Millstone Nuclear Power Station, Unit Nos. 2 and 3
Proposed Change to Revision 22 of the
Northeast Utilities Quality Assurance Program Topical Report

Attachment 1: Proposed Changes to the Northeast Utilities Quality Assurance Program, Organizational Changes Regarding Reporting Relationships and Modification of the Requirement to Perform a Special Audit

Enclosure 1: Proposed Changes to Revision 22 of the Northeast Utilities Quality Assurance Program Topical Report Sections 1.0 and 18.0, and Appendices E and F

1.8 ORGANIZATION CHARTS

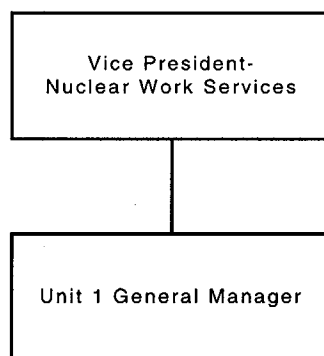
It is proposed that Oversight report directly to MPO - Assessment; however, as delegated and defined in Section 1.0 of the NUQAP Topical Report, the PO - Oversight will have direct access to the SVP & CNO for quality related matters. This relationship provides for the independence of the Oversight organization for quality related issues.

The proposed change does not modify the responsibilities of the PO - Oversight from those previously assigned to the Nuclear Oversight Director. Previously, the responsibility for implementing the quality assurance program was transferred from the Nuclear Oversight Director to the Nuclear Oversight Manager (renamed the PO - Oversight during the past reorganization). These

The proposed change results in the Oversight Department reporting to the MPO - Assessment; however, under the process based organization recently implemented at Millstone, the PO - Oversight has direct access to the SVP & CNO for quality related matters. This relationship is indicated by the dotted line on Figure 1.0 in Section 1.0 of the NUQAP. The proposed organization thus provides Oversight the required authority and organizational freedom required by 10 CFR 50 Appendix B. However, due to the modifications in the reporting relationship, in accordance with 10 CFR 50.54(a)(4), this change is considered a reduction in commitment and is being submitted to the NRC prior to implementation.

Currently the ISEG reports to the Process Owner - Oversight. Implementing the proposed changes with the new organizational scheme results in the ISEG reporting organizationally to the Process Owner - Performance Improvement who together with several other Process Owners (e.g., Oversight, Regulatory Affairs and Emergency Planning) reports to the Master Process Owner (MPO) - Assessment. The MPO - Assessment reports to "a high level technically oriented management position," the Vice President - Nuclear Technical Services, who reports directly to the SVP & CNO. The Vice President - Nuclear Technical Services (officer) is not in the direct chain of command for power production. Therefore, this reporting relationship provides the ISEG with access (organizationally - via the chain of command) to the Vice President - Nuclear Technical Services.
